Date: March 2, 2023
To: Dago Garcia, P.E., City Engineer
Cc: Roy Reyes, PE, Project Engineer
Jamie Van Agtmael, PLS, President, LEI Engineering & Surveying
From: Colin Cortes, AICP, CNU-A, Senior Planner *cc*
Subject: **Planning Division review comments on 3rd / 2st revised submittal
November 4, 2022 of civil engineering plans for Allison Way Apts. Ph. 2**

Planning Division staff identifies on item needing resolution before sign-off on Public Works Department Engineering Division approval and issuance of civil engineering plans for Allison Way Apartments Phase 2 (DR 2019-05) along the east/southeast side of Allison Way south of Hooper Street.

G. Condition EX2b: Relating to the Stacy Allison Way extension, demonstrate conformance regarding: ...

PREPARED BY: G. ZARTMAN
 CHECKED BY: G. ZARTMAN
 DATE: 05/24/2024
 PROJECT: 60-10
 SHEET: SP-1
 SCALE: 1" = 40'
 DRAWING NO: 25 OF 34

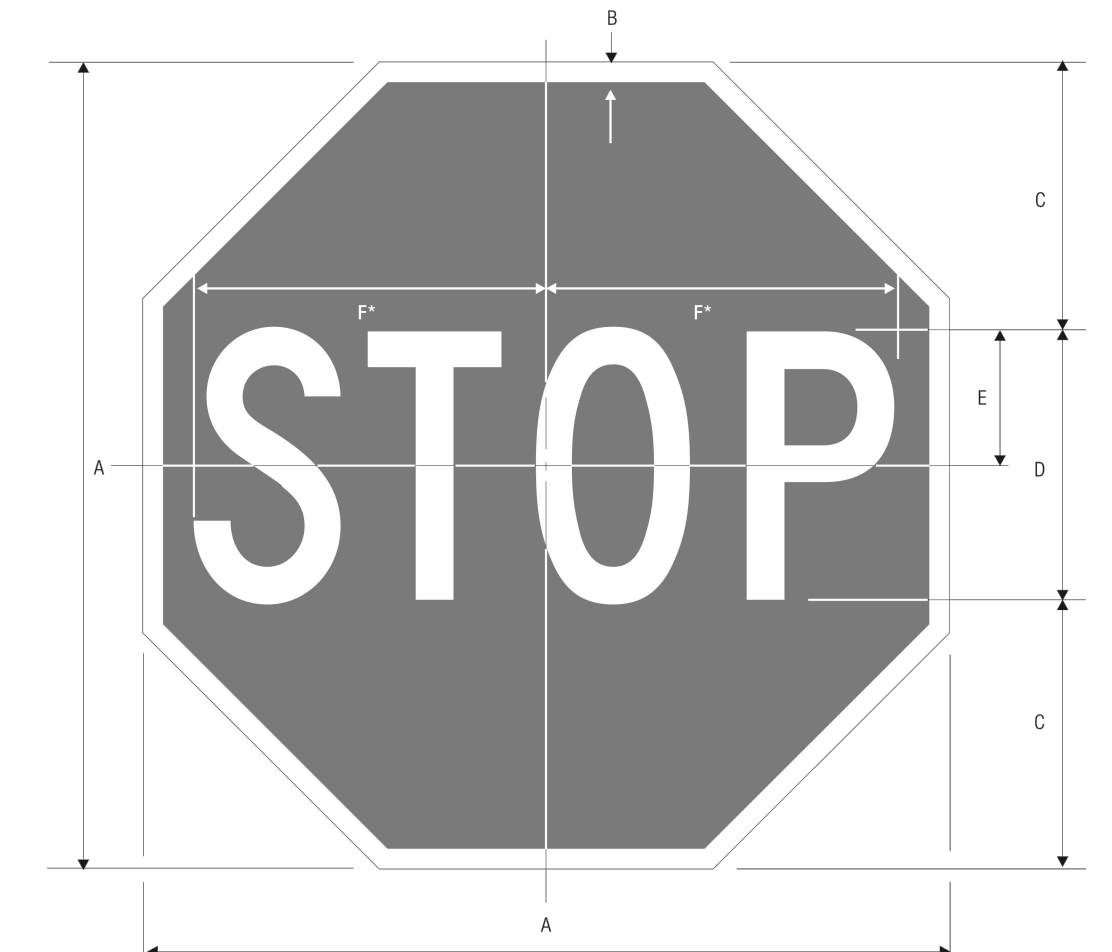
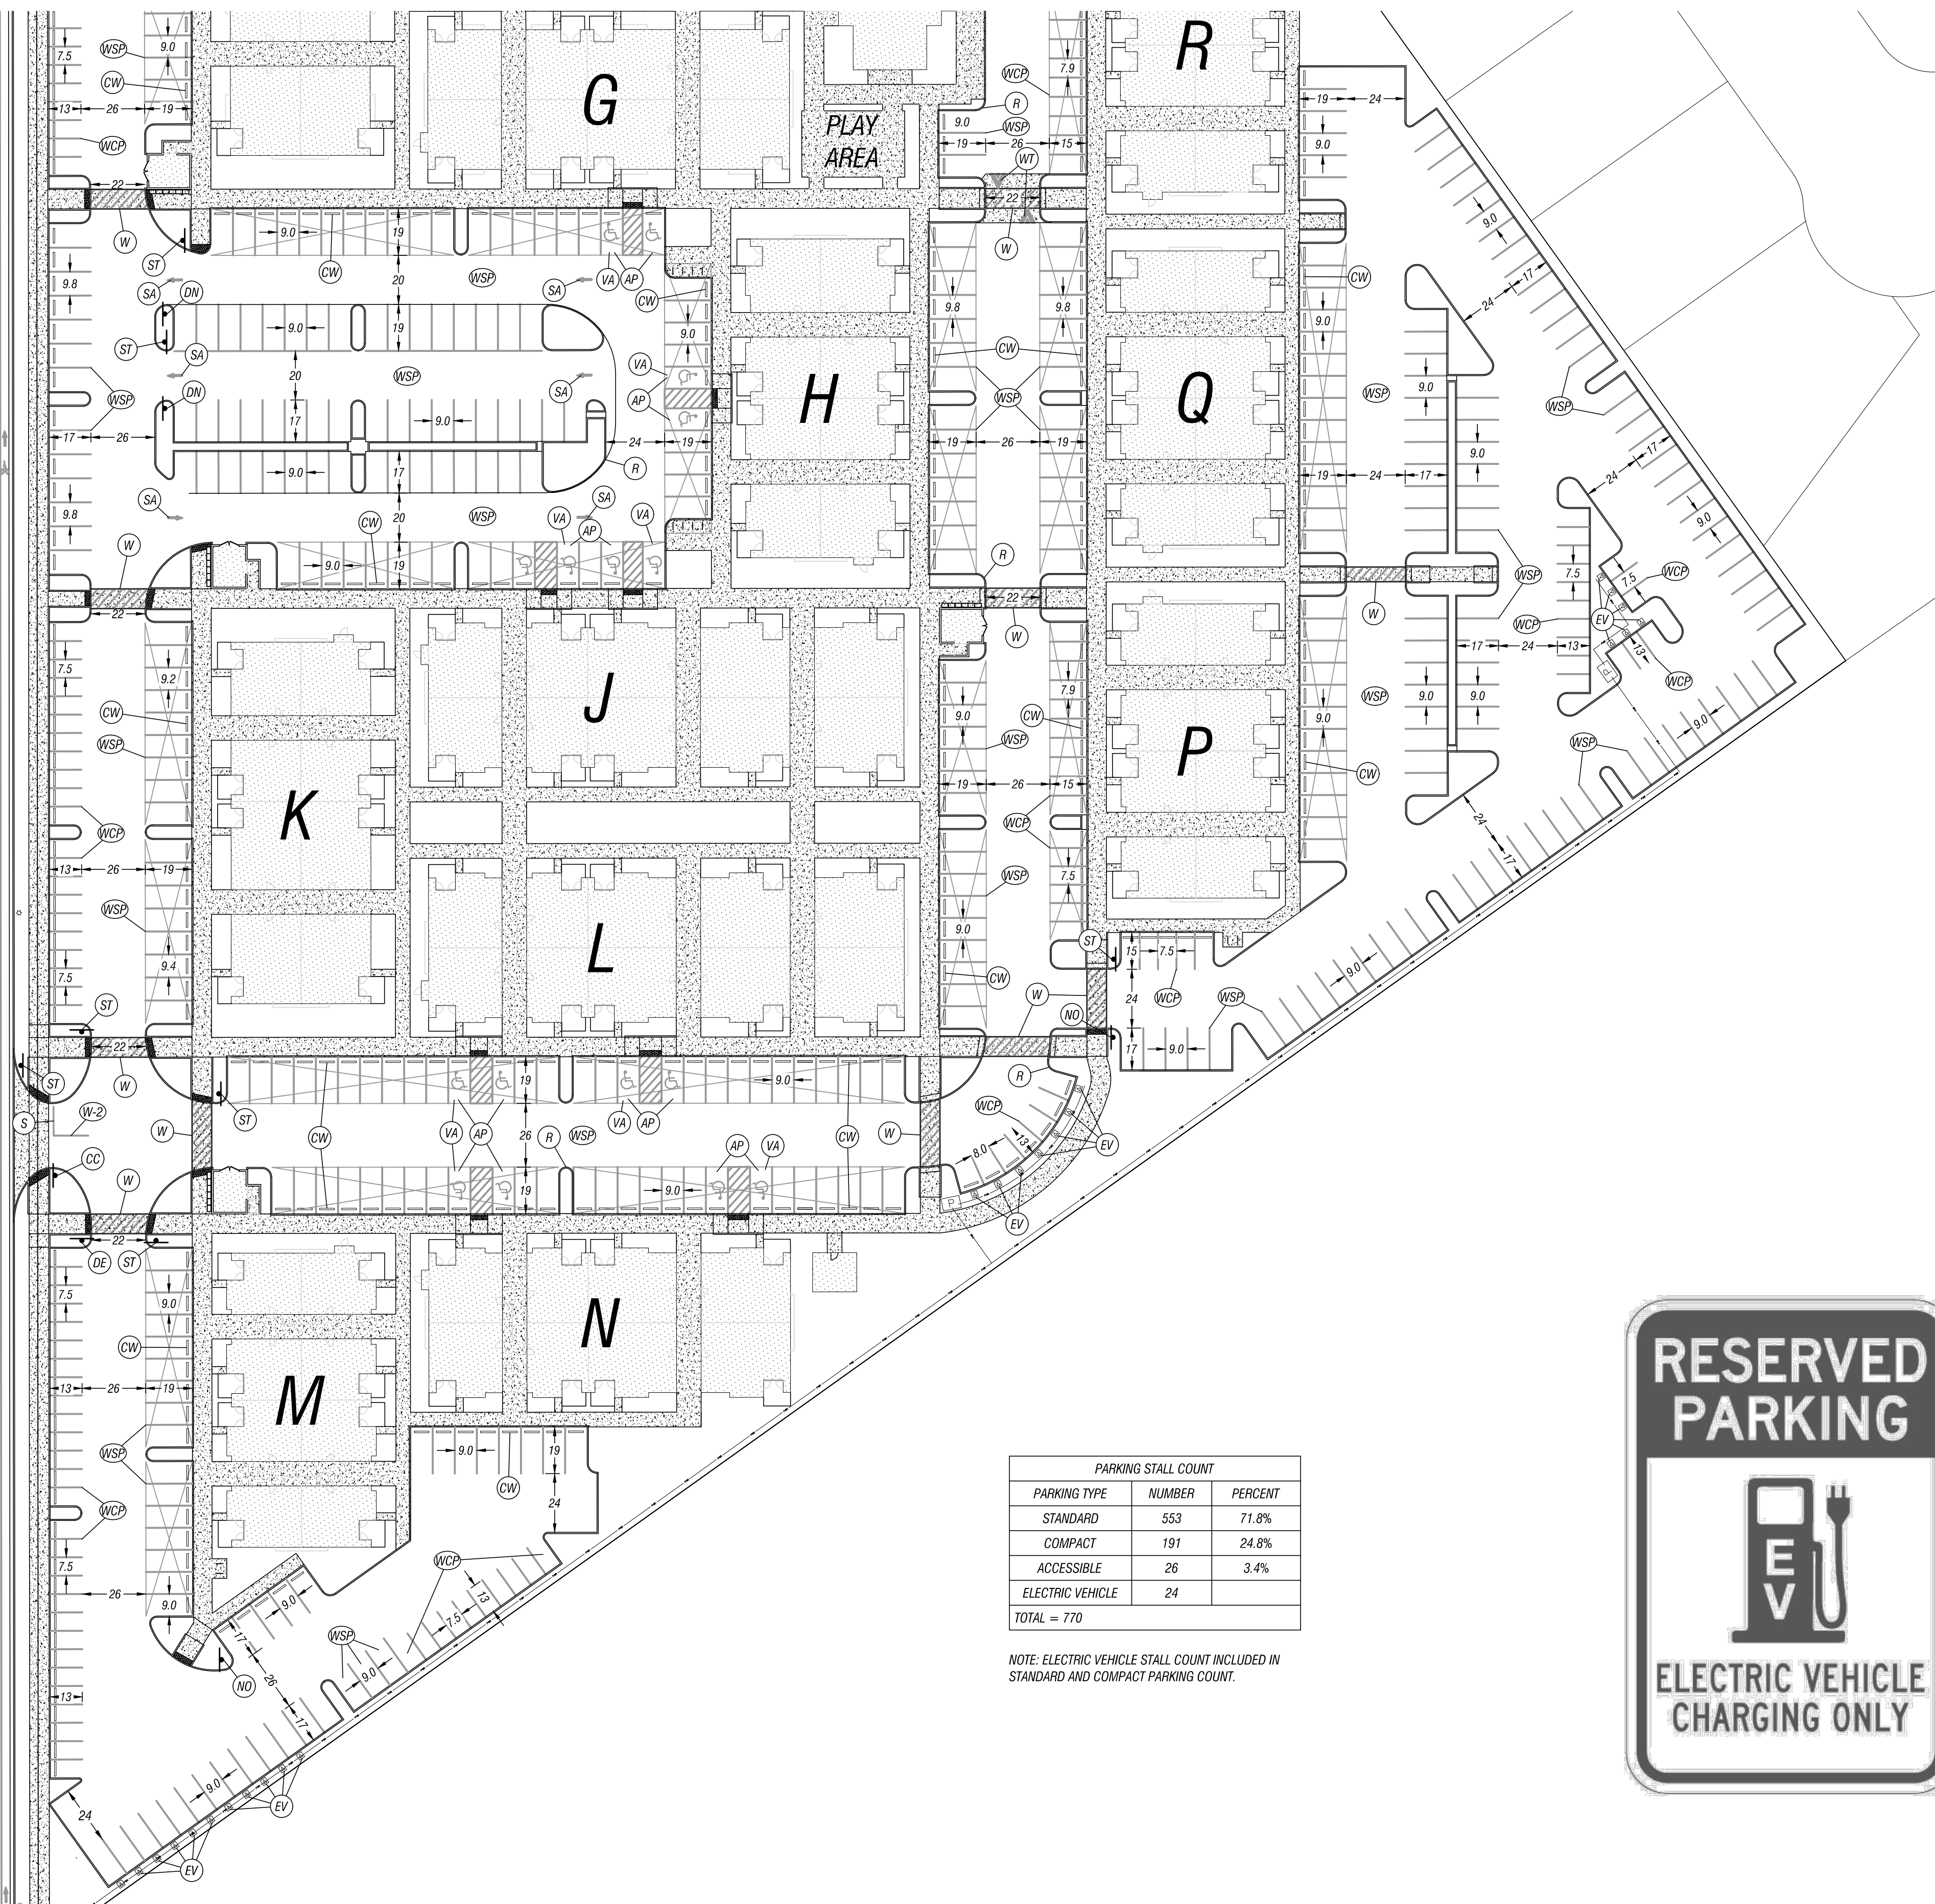
- (ii) Regarding, "The developer shall also install an MUTCD-compliant dead-end sign, either W14-1 or W14-2, at the intersection of Allison & Hooper for southbound drivers", revise Sheet SP-1 "Striping Plan" (Sheet 25), which is also a traffic control signage sheet, to add a symbol with note reference to a construction note relevant to the requirement and to add an image of the sign.

SHEET: 26 OF 34

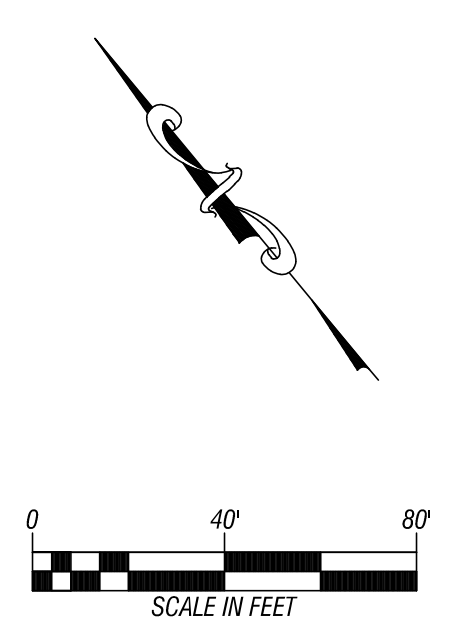
- Part (9): Interim signage. Revise Sheet SP-2.

- (i) Regarding "Signed barricades remain required per WDO 3.01.05A.2.b & c. and to PW SS&Ds", illustrate and note conformance. Specify the revised sheet(s), which needs to include Sheet SP-2 "Striping Plan" (Sheet 26).

- (iii) Regarding, "The City Engineer may require the developer to install either (a) also at the intersection either a W14-1a or a W14-2a sign to warn drivers turning south from Hooper that Allison ends in the left direction as the arrow within the sign copy would indicate, or (b) a sign or signs serving similar purpose," provide a status update confirming yes or no. If yes, revise Sheet SP-2 "Striping Plan" (Sheet 26) to add a symbol with note reference to a construction note relevant to the requirement and to add an image of the sign. (Note: SP-2 as drawn cuts off the south end of the Stacy Allison Way improvements.)
